DESIGN REVIEW BOARD – URBAN DESIGN PANEL

**Planning Staff Report to
Design Review Board - Urban
February 26, 2021**
for the March 4, 2021 Public Hearing

CA 20-775 • 330 WOODRUFF ROAD

Site Plan

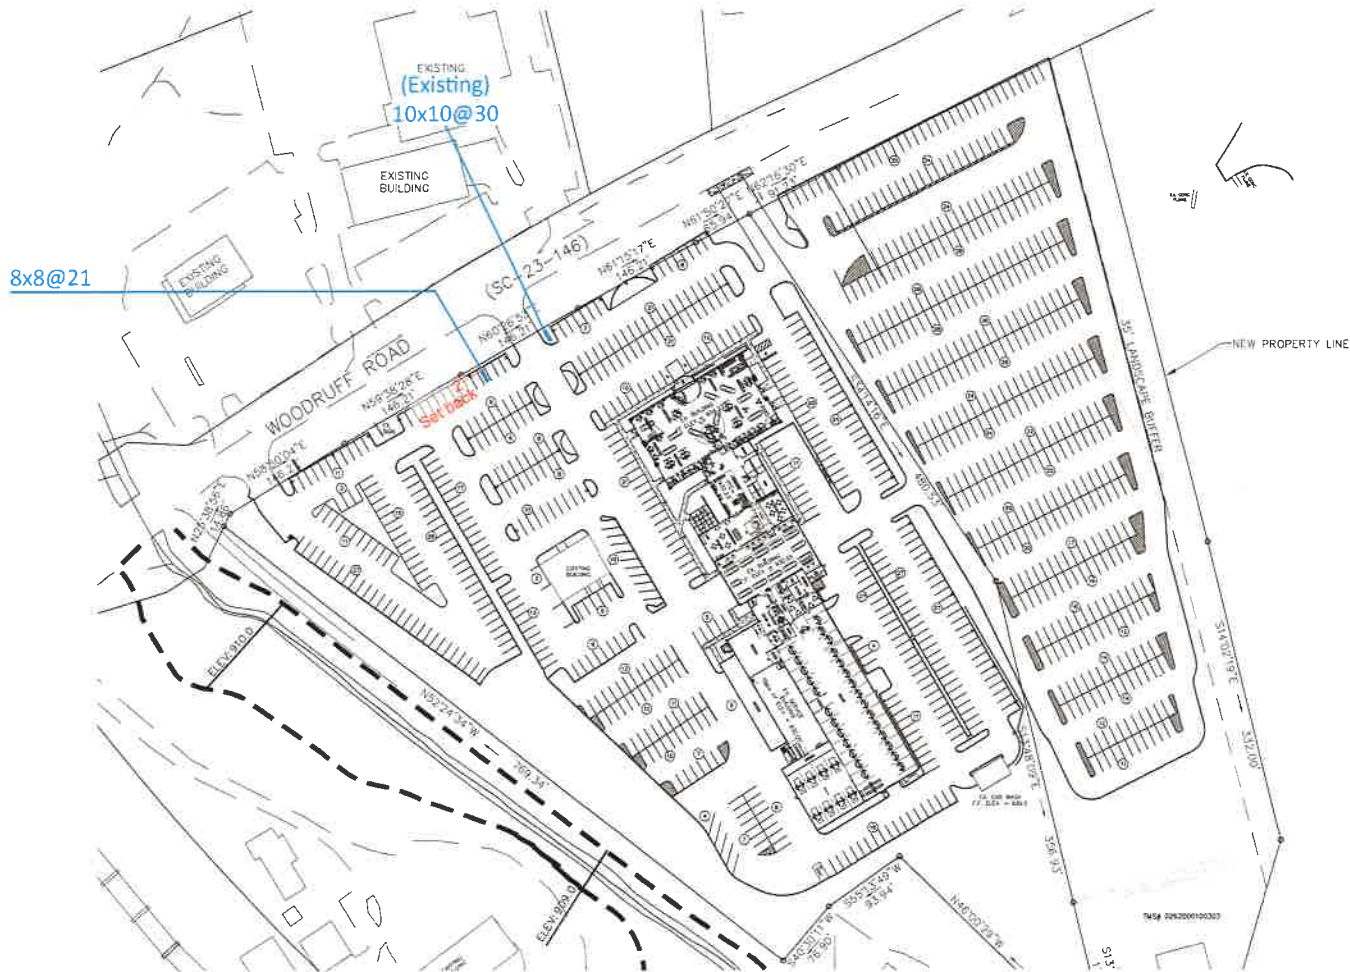
- 1. Landscaping should be added to the base as it is a listed incentive to help break up the sign base's massing. This landscaping plan to be submitted to staff for review and approval prior to permitting.**
- 2. Relocate the sign away from the existing 30-foot sign to a location further west on Woodruff Road in order to prevent the current signage clutter. This would nearly double the distance between the signs from their current placements.**

MONOLITH PYLONS

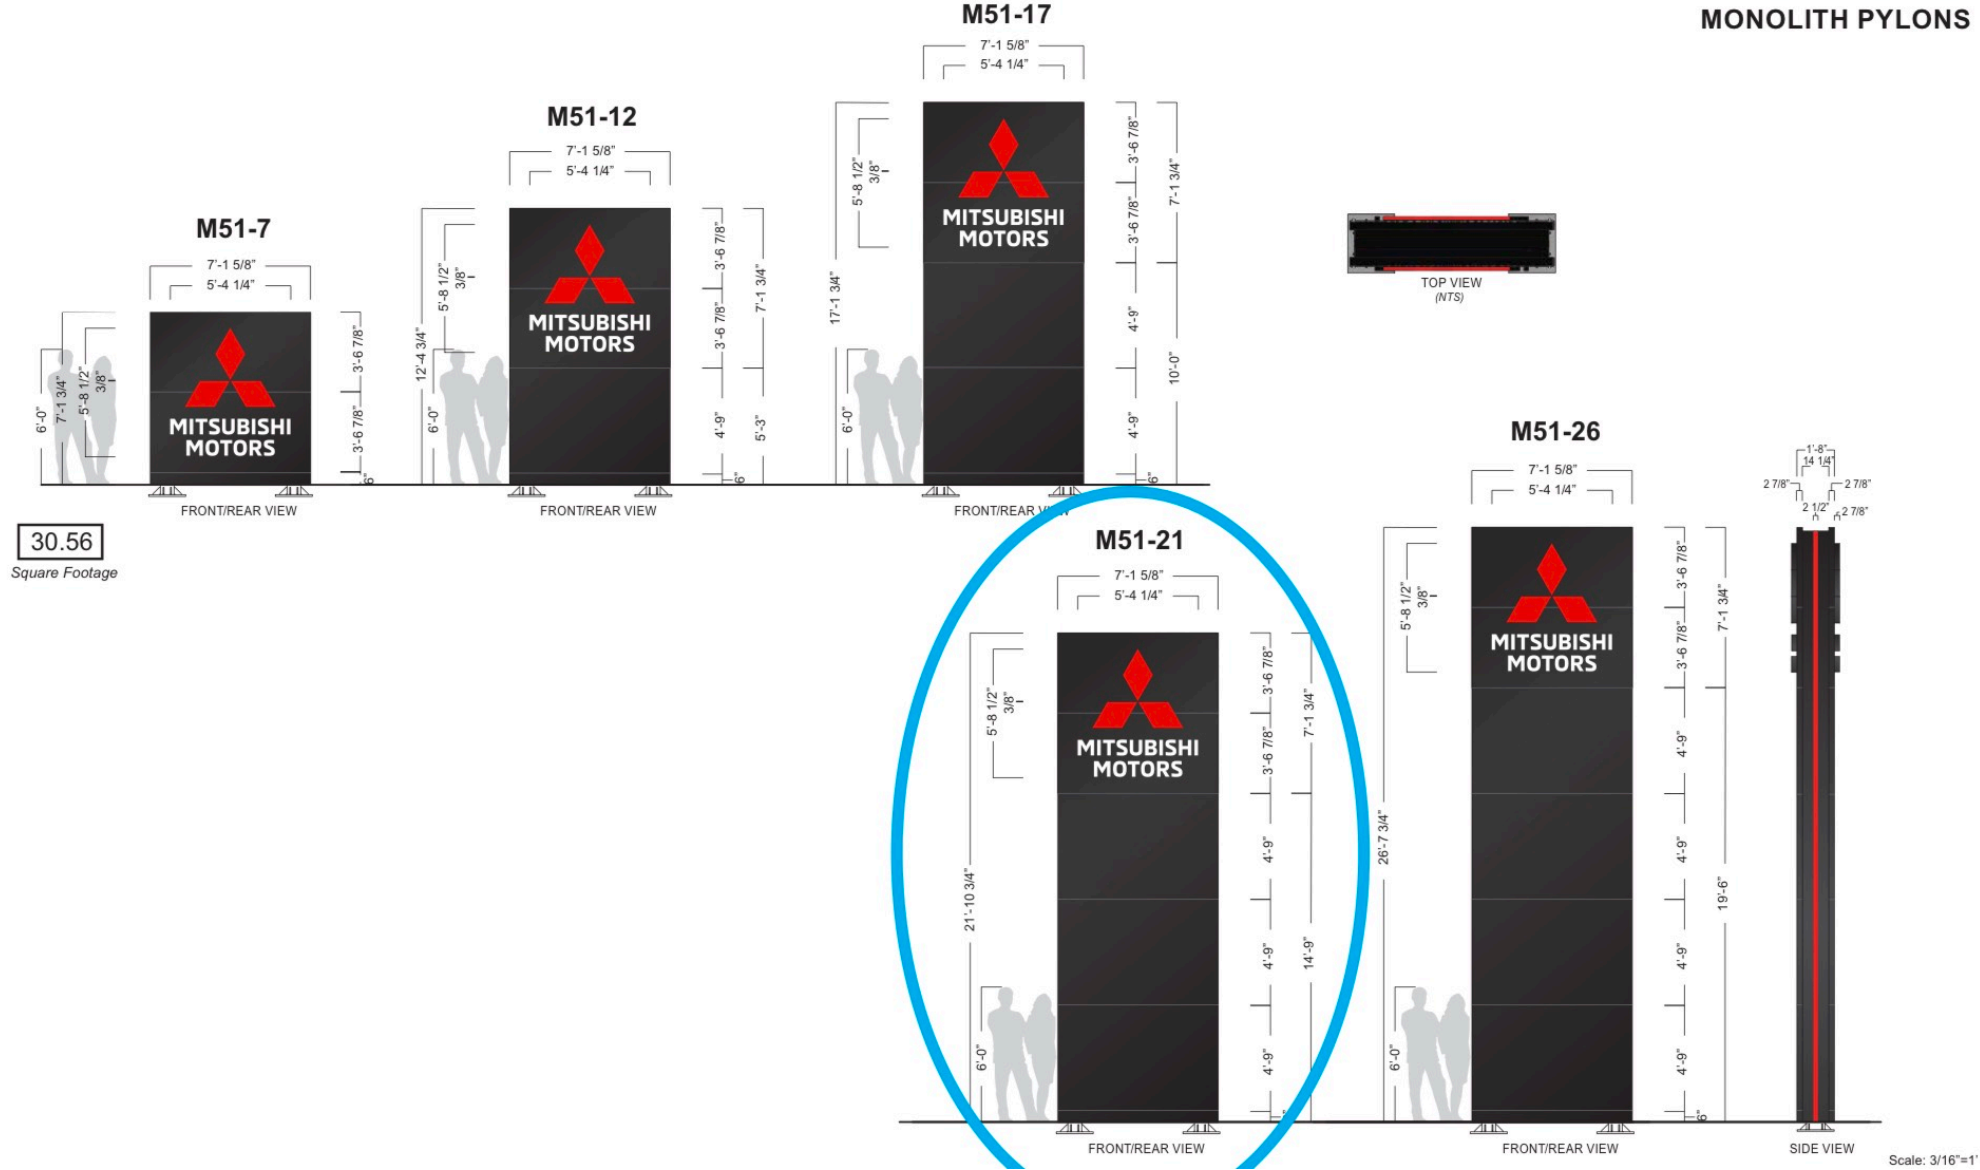
The applicant provided information to determine that the sign will use similar colors to the canopy of the existing building on site – black and red. This portion of the old Saturn dealer was repainted recently with moving in the new tenant, Mitsubishi. The design itself does not appear to provide a special privilege or entitlement. However, allowing the freestanding sign at nearly 22 feet tall would appear to provide a special height privilege

The applicant did not provide sufficient information to make this determination. While staff does know of the intended materials and how the sign's design will relate to the building, staff cannot make a final determination on whether or not the sign will create visual clutter without knowing the design, size, and placement of the "The Truck Farm" sign.

FIRST FLOOR PLAN

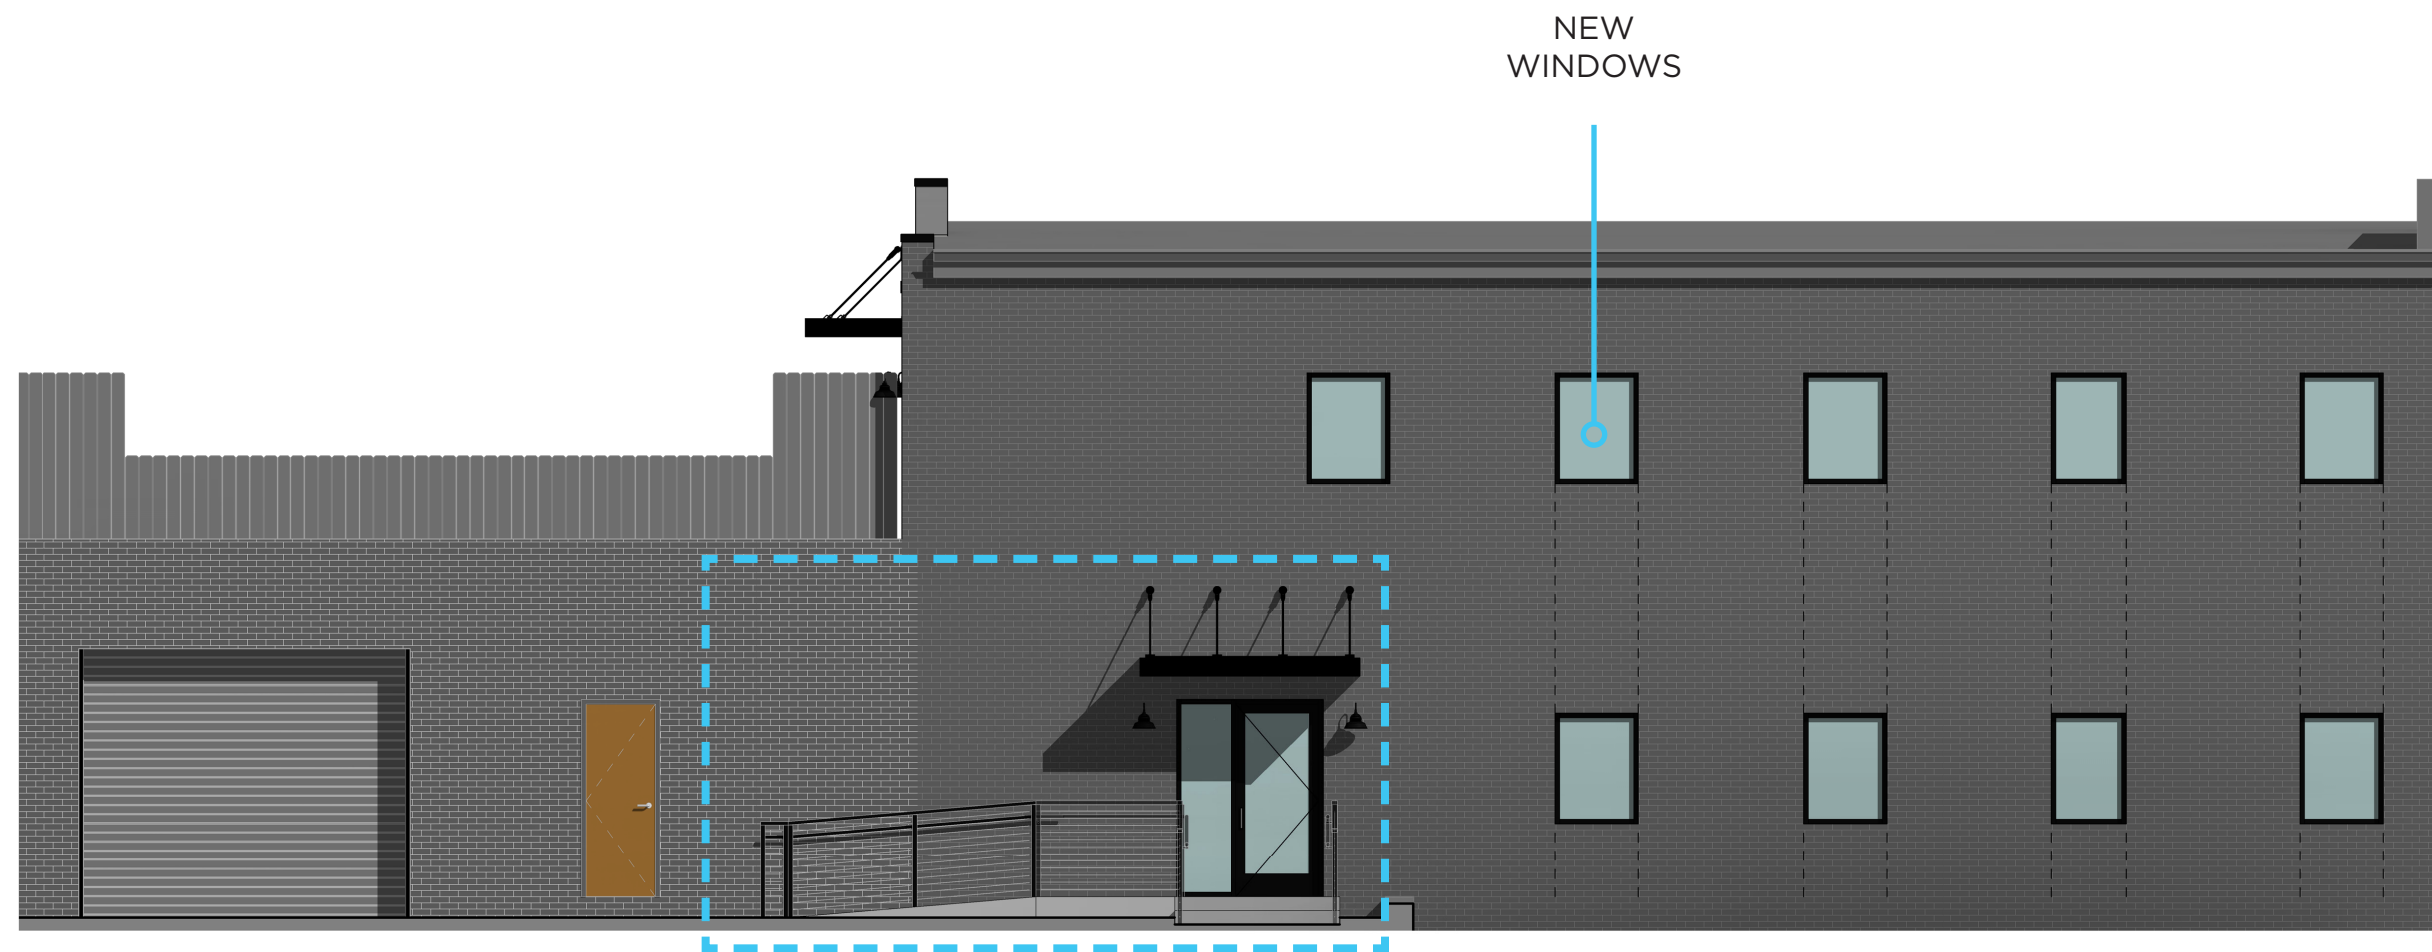
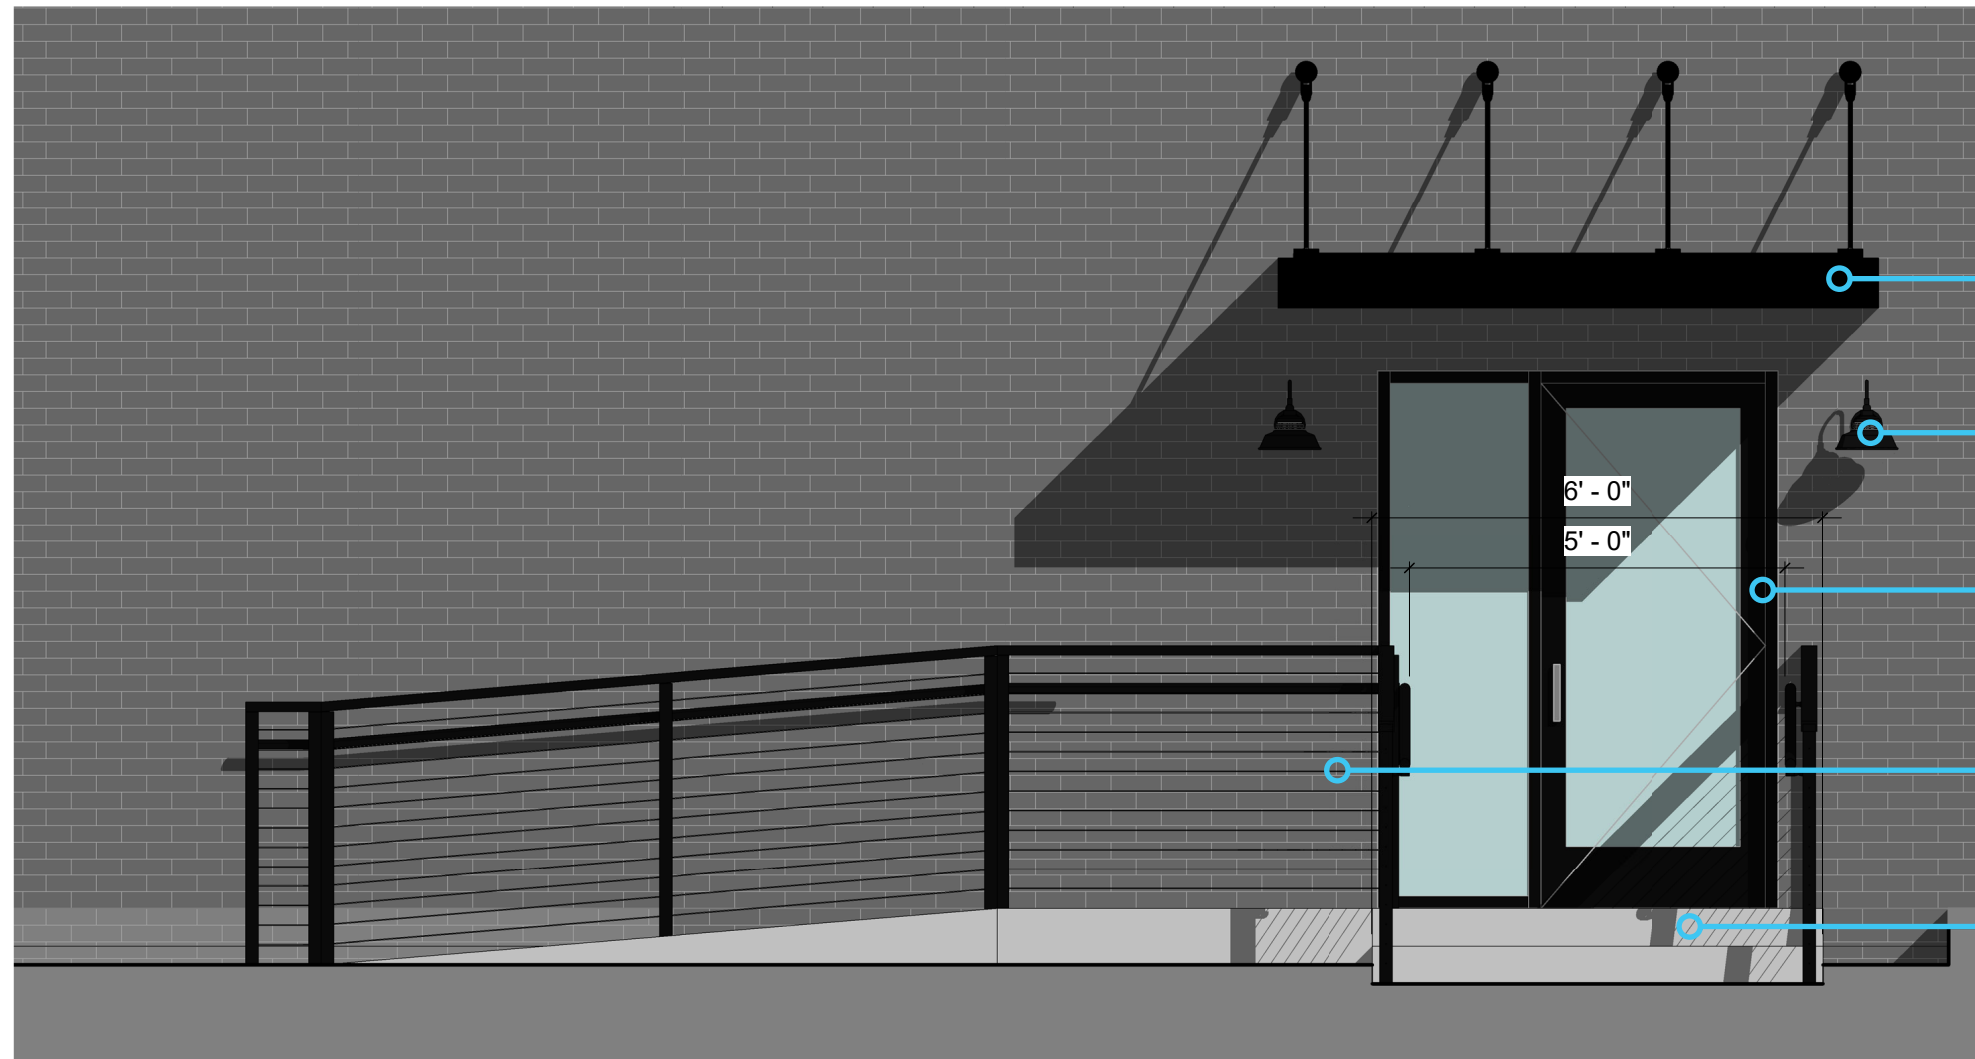
Staff notes that the applicant has not provided details or specification sheets for the proposed overhead doors, gooseneck lights, or storefront windows and doors. Further, staff notes that the improvements to the rear façade appear to require the relocation of existing HVAC units. If the intent is to relocate the HVAC units to the rooftop, an architectural parapet shall be installed to shield their visibility from grade. A separate Certificate of Appropriateness application will be required for new and modified exterior signage.

- **The applicant shall provide details of the overhead door and window systems, gooseneck lighting, and HVAC unit location at the time of building permit submittal; if HVAC units are relocated to the roof, they shall be screened from grade by an architectural parapet; and**
- **New door and window glass shall not feature dark tint or reflective material.**
